Item Name: Floor Provisions - Energy Attenuating Seat Compatible

**DART SERVICE INSTRUCTION**  
**TO AMEND INSTALLATION INSTRUCTIONS IIN-D350-689 REV. B**  
**AND INSTRUCTIONS FOR CONTINUED AIRWORTHINESS ICA-D350-689 REV. 1**  
REF. TCCA STC: SH02-33  
REF. FAA STC: SR01620NY  
REF. EASA STC: EASA.IM.R.S.01453  
REF. TCA STC: 2005S03-09

B	CHANGES TO -013 KIT INSTALLATION. REF: CIR12-12.	MB	12.11.09
A	NEW ISSUE	MB	11.12.22
REV.	DESCRIPTION	BY	DATE
DESIGN		<b>DART AEROSPACE LTD</b>	
DRAWN		HAWKESBURY, ONTARIO, CANADA	
CHECKED		DRAWING NO.	REV. B
MFG. APPR.	N/A	DSI 9588	SHEET 1 OF 6
APPROVED		TITLE	SCALE
DE APPR.		INSTALLATION CHANGE	NTS
DATE	12.11.09	COPYRIGHT © 2011 BY DART AEROSPACE LTD THIS DOCUMENT IS PRIVATE AND CONFIDENTIAL AND IS SUPPLIED ON THE EXPRESS CONDITION THAT IT IS NOT TO BE USED FOR ANY PURPOSE OR COPIED OR COMMUNICATED TO ANY OTHER PERSON WITHOUT WRITTEN PERMISSION FROM DART AEROSPACE LTD.

**FIGURE 1: UPDATES TO CROSS SECTIONS F-F AND M-M**  
 With reference to Figures 5 and 7 of IIN-D350-689  
 (Figures 25-5 and 25-7 of ICA-D350-689)

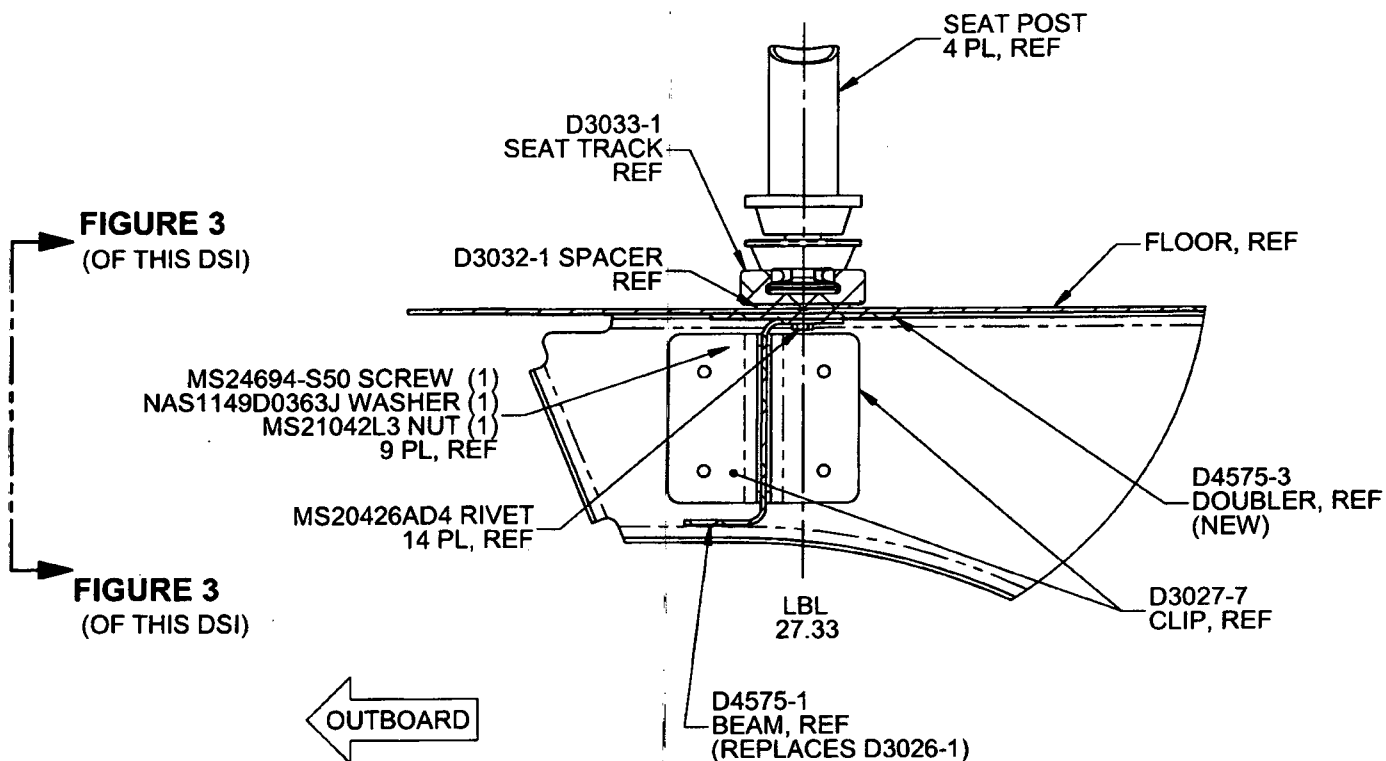
If there is an existing stringer at LBL 27.33, it will need to be removed from that location. Locate D4575-1 Beam, D4575-3 Doubler, and D3032-1 Spacer as shown in Figure 1 of this Service Instruction. Transfer drill existing holes from the aircraft floor to the D4575-1 Beam, D4575-3 Doubler, and D3032-1 Spacer. Ensure 1.0" to 1.5" rivet pitch and add additional holes if required. If there is no existing stringer, locate D4575-1 Beam, D4575-3 Doubler, and D3032-1 Spacer as shown in Figure 1 of this Service Instruction and drill Ø0.128" holes on a 1.0" to 1.5" pitch.

Counter sink holes in the D3032-1 Spacer for MS20426AD4 rivets. Install D4575-1 Beam, D4575-3 Doubler, and D3032-1 Spacer to floor using MS20426AD4 rivets.

**FIGURE 2: UPDATES TO FIGURE 21 (IIN-D350-689) AND 25-21 (ICA-D350-689)**  
 With reference to Figures 19 and 20 of IIN-D350-689  
 (Figures 25-19 and 25-20 of ICA-D350-689)

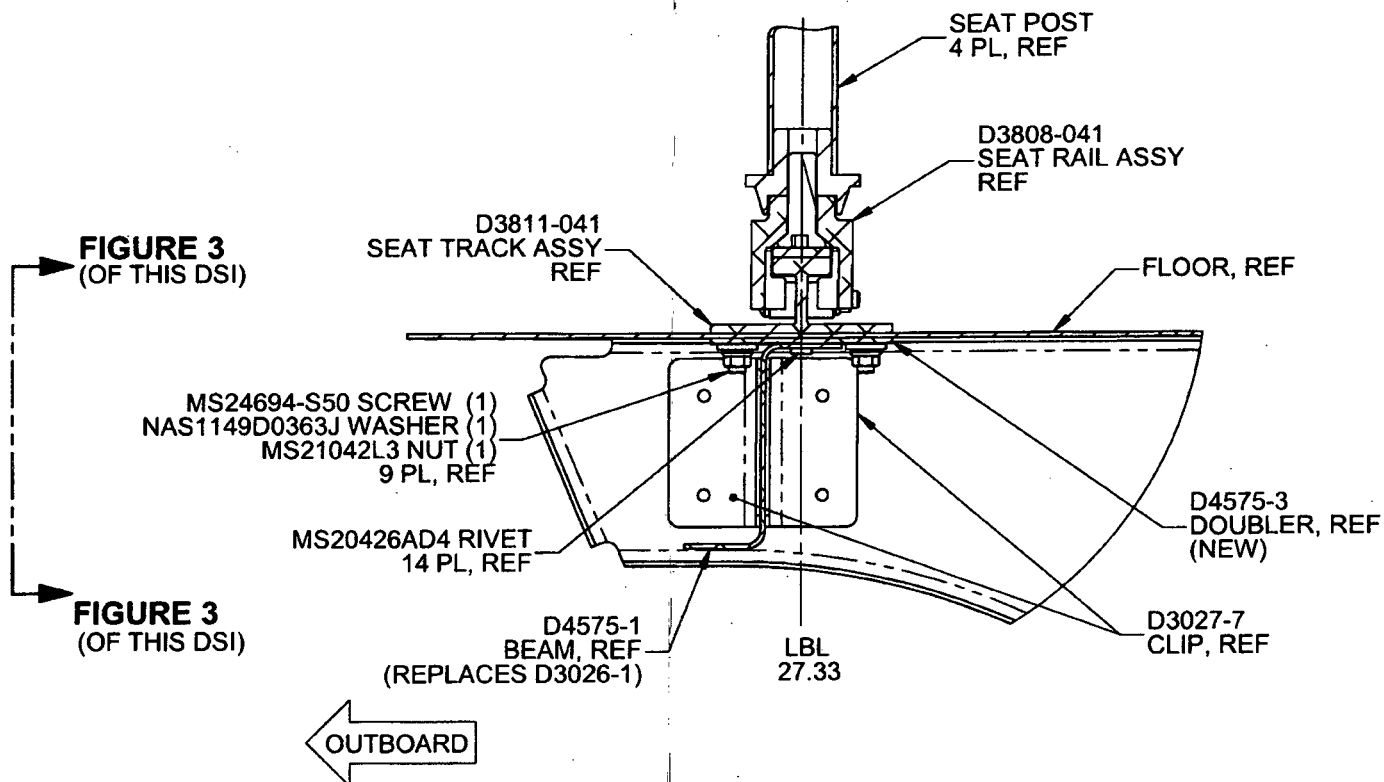
If there is an existing stringer at LBL 27.33, it will need to be removed from that location. Locate D4575-1 Beam and D4575-3 Doubler as shown in Figure 2 of this Service Instruction. Transfer drill existing holes from the aircraft floor to the D4575-1 Beam and D4575-3 Doubler. Ensure 1.0" to 1.5" rivet pitch and add additional holes if required. If there is no existing stringer, locate D4575-1 Beam and D4575-3 Doubler as shown in Figure 1 of this Service Instruction and drill Ø0.128" holes on a 1.0" to 1.5" pitch.

Attach D4575-1 Beam and D4575-3 Doubler to floor using qty (14) MS20426AD4 rivets.

**FIGURE 3: RELIEFS ON D4575-1/-3**  
(ONLY D4575-1/-3 SHOWN FOR CLARITY)  
VIEW LOOKING INBOARD

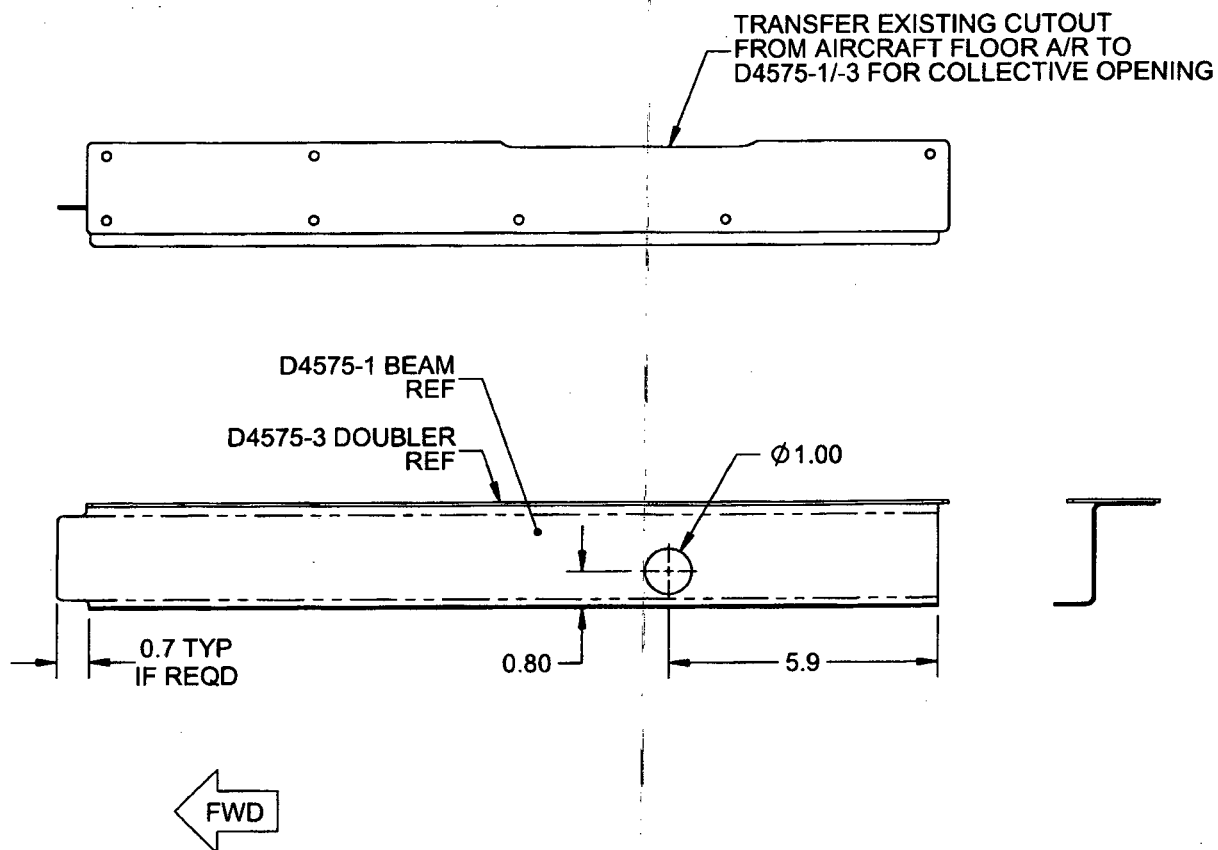
**Note:** Drill a Ø1.00" (Ø25.4 mm) hole in the D4575-1 Beam to clear extension tube of collective and cutout as required for clearance of collective opening and fwd bulkhead as shown in Figure 3 of this Service Instruction.

**Note:** Drill a Ø1.00" (Ø25.4 mm) hole in the D4575-1 Beam to clear extension tube of collective and cutout as required for clearance of collective opening and fwd bulkhead as shown in Figure 3 of this Service Instruction.
